SUBJECT: CORRECTION TO AMENDMENT 33 TO FACILITY OPERATING LICENSE NPF-86
(TAC M87849)

On November 23, 1994, the Commission issued Amendment 33 to Facility Operating License NPF-86 for the Seabrook Station, Unit No. 1. It has been brought to my attention that revised page 2-2 as issued did not include revised Figure 2.1-1. Please substitute the enclosed corrected copy of Page 2-2. For convenience, overleaf page 2-1 is included.

Seabrook Station, Unit No. 1

FIGURE 2.1-1

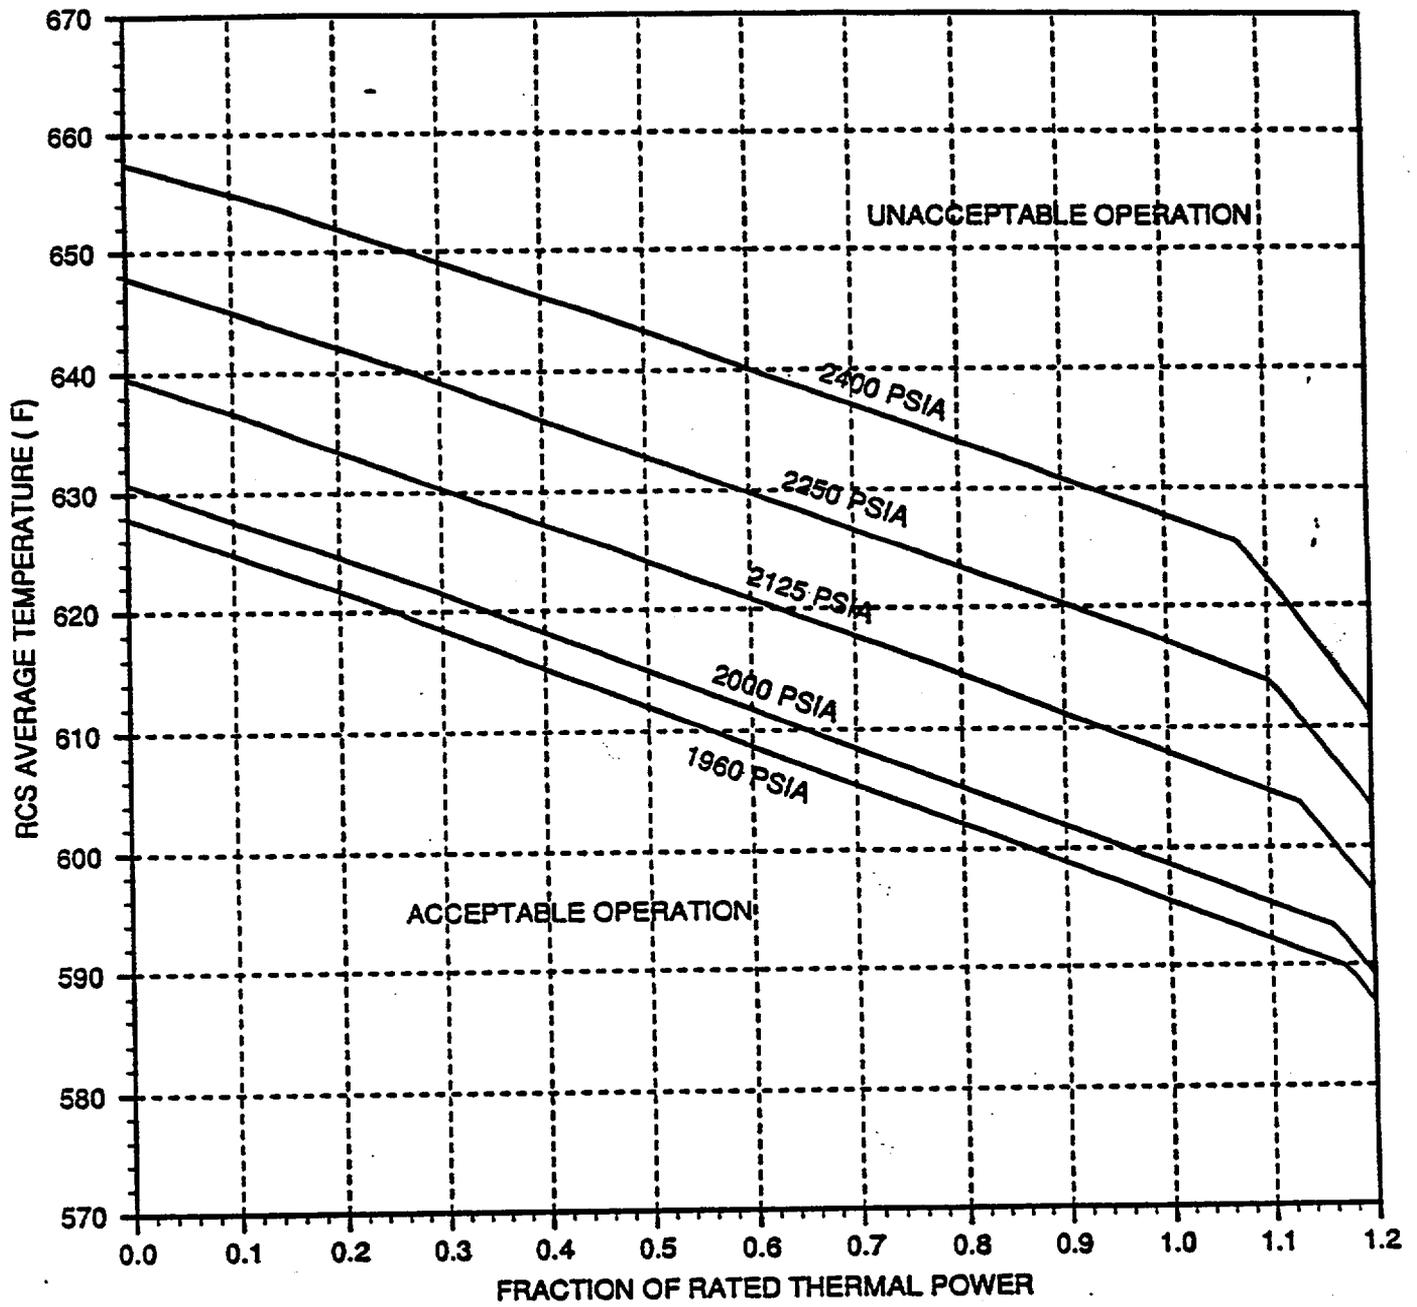
On November 23, 1994, the Commission issued Amendment 33 to Facility Operating License NPF-86 for the Seabrook Station, Unit No. 1. It has been brought to my attention that revised page 2-2 as issued did not include revised Figure 2.1-1. Please substitute the enclosed corrected copy of Page 2-2. For convenience, overleaf page 2-1 is included.

2.1.1 The combination of THERMAL POWER, pressurizer pressure, and the highest operating loop coolant temperature (T_{avg}) shall not exceed the limits shown in Figure 2.1-1 for four-loop operation.
